## VALUE ENGINEERING CONSTRUCTABILITY STUDY OF

I-285 INTERCHANGE/SR 8/US 29 IM-NH-285-1(347) PI No. 713320-

> ATLANTA, GEORGIA JANUARY 23, 2006

Prepared by: VE GROUP, L.L.C.

MATCHING NEW RAMP GRADES WITH INTERSECTION

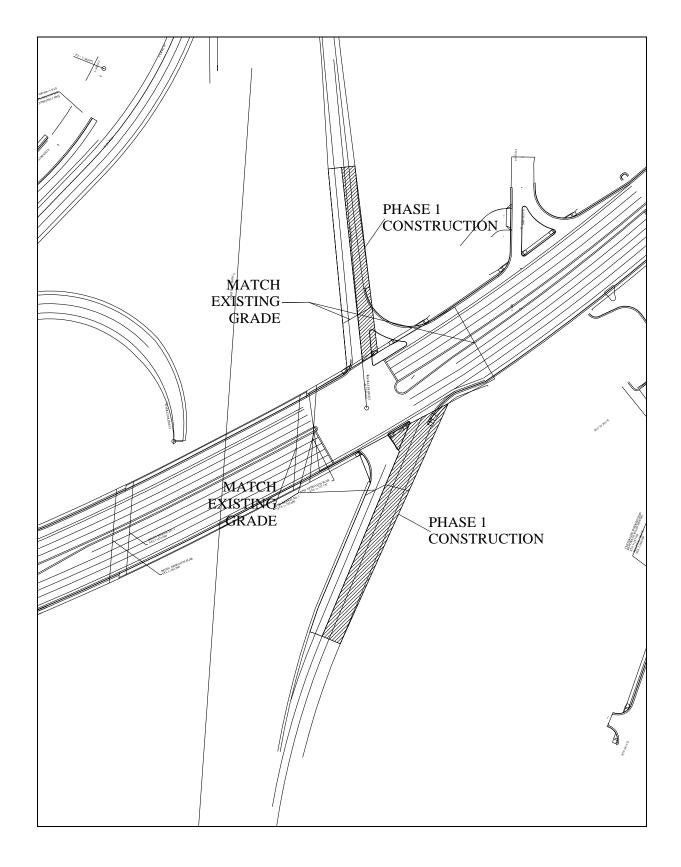
The Value Engineering Team recommends raising the intersection grade over 4 to 5 nights after the new L-3 and L-4 ramp widenings have been completed. It is assumed three to four inch lifts per night. The maximum grades approaching the intersection will be 6.0% to minimize paving on the existing bridge.

Ramps L-3 and L-4 grades will have to be raised each night to meet the raised intersection. The maximum grade for the ramps will be limited to 6.0% to reduce the amount of paving on the ramps.

**As Proposed Bridge Foundation**

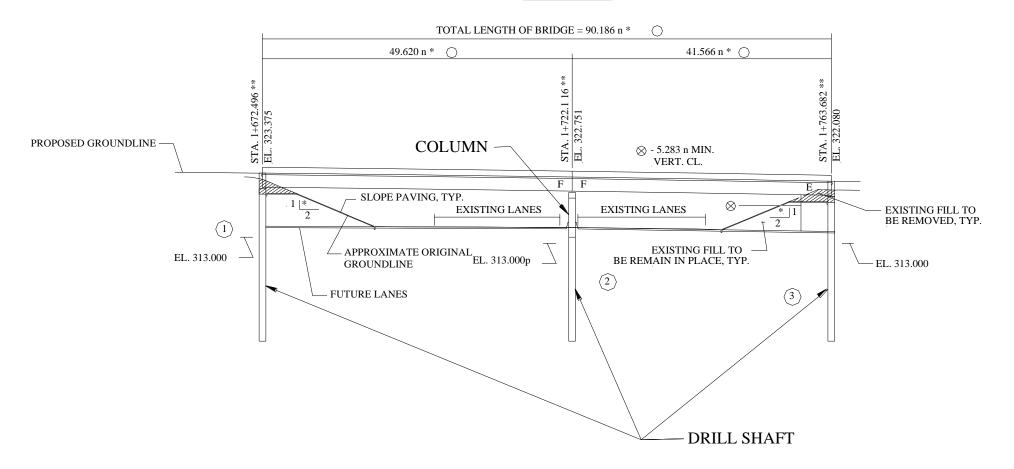
The proposed foundations for the replacement bridge consist of footings on piles for Bent 1 & 3 (End Bents), and spread footings for Bent 2. Because the End Bents are designed as interior bents to accommodate future lengthening of the bridge, the pile footings will be constructed below the grade of I-285. The use of footings on piles at this elevation will require shoring in order to maintain traffic during staging. The 2:1 end slope will remain in place until the bridge is lengthened, at which time the material around the end bents will be removed and become interior bents. The shoring will only be installed parallel to the centerline between the existing bridge and the staged construction of the proposed bridge. The excavation for Bent 2 in the median will require shoring on all sides. This method of foundation construction requiring driving of sheeting, excavation of material inside the shored area, building the footing formwork, and pouring the concrete is, at best, a time consuming process.

The Value Engineering Alternative consists of using Drilled Shafts at all Bents. The Drilled Shafts will be approximately the same diameter as the columns and will extend below and support the columns at Bent 2. At the End Bents the Drilled Shaft will become the column above the I-285 grade when the end slope material is removed and the bridge is lengthened. Because the Drilled Shaft is constructed inside a casing that extends to the ground surface, shoring, footing excavation, and forming, is eliminated. This speeds up the construction of the bents greatly and contributes to a safer work site. At the End Bents, a temporary form liner can be used in the borehole to insure that a smooth concrete surface will be exposed when the surrounding earth is removed.

The advantages of this alternative are that drilled shaft construction is cost effective and will reduce construction time. In addition, pile driving resulting in noise pollution will be eliminated.
